# Access Compliance Report

## Public Rights-of-Way

Intersection ID: 12160	Main Street: E_9TH_ST	Cross Street: N_BREVARD_ST	Location: E
ADA ID: 961B1347BE45	Ramp Type: PerpDiag	Initial Pass/Fail: Fail	Overall Compliance: No
		Severity Score: 25

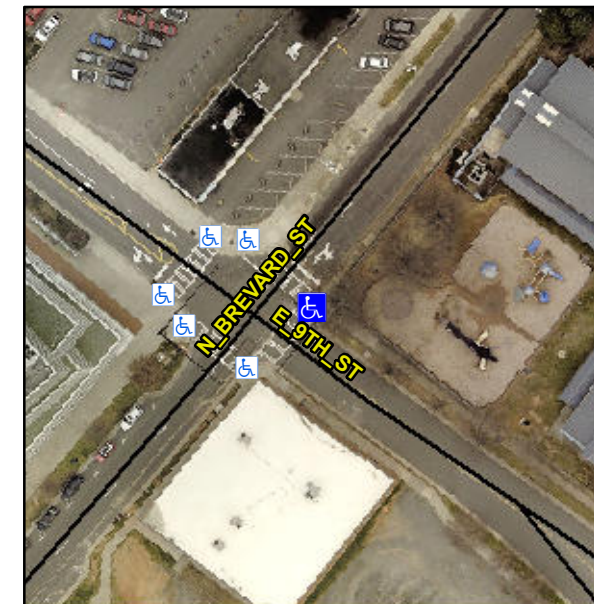
**Not Found, R304.2.2, R304.5.3**

Compliance	Description	Data	Compliance	Description	Data
N/A	Ramp Length (in)	48.0	No	Ramp Slope (%)	10.6
Yes	Ramp Width (in)	62.0	No	Ramp XSlope (%)	6.6
N/A	Flare Type LT	N/A	N/A	Flare Type RT	N/A
N/A	Flare Slope LT (%)	N/A	N/A	Flare Slope RT (%)	N/A
N/A	Flare Traversable LT?	N/A	N/A	Flare Traversable RT?	N/A
N/A	Landing Length (in)	N/A	N/A	DWS Provided?	N/A
N/A	Landing Width (in)	N/A	N/A	DWS Contrast?	N/A
N/A	Landing Slope (%)	N/A	N/A	DWS Length (in)	N/A
N/A	Landing X Slope (%)	N/A	N/A	DWS Full Width?	N/A
N/A	Landing Curb? (Y/N)	N/A	N/A	DWS Offset (in)	N/A
N/A	Shared Landing?	N/A			
N/A	Gutter Ponding?	N/A	N/A	Gutter Slope (%)	N/A
N/A	Gutter Lip Ht (in)	N/A	N/A	Gutter X Slope (%)	N/A
N/A	Painted X Walk1?	Yes	N/A	Painted X Walk2?	Yes
	X Walk 1 Direction	To NW		X Walk 2 Direction	To SW
N/A	X Walk 1 Width (in)	109.0	N/A	X Walk 2 Width (in)	111.0
	X Walk 1 Slope (%)	3.1		X Walk 2 Slope (%)	0.7
	X Walk 1 X Slope (%)	5.1		X Walk 2 X Slope (%)	4.0

**Remove & Replace Curb Ramp With Two New Directional Ramps or Equivalent.**
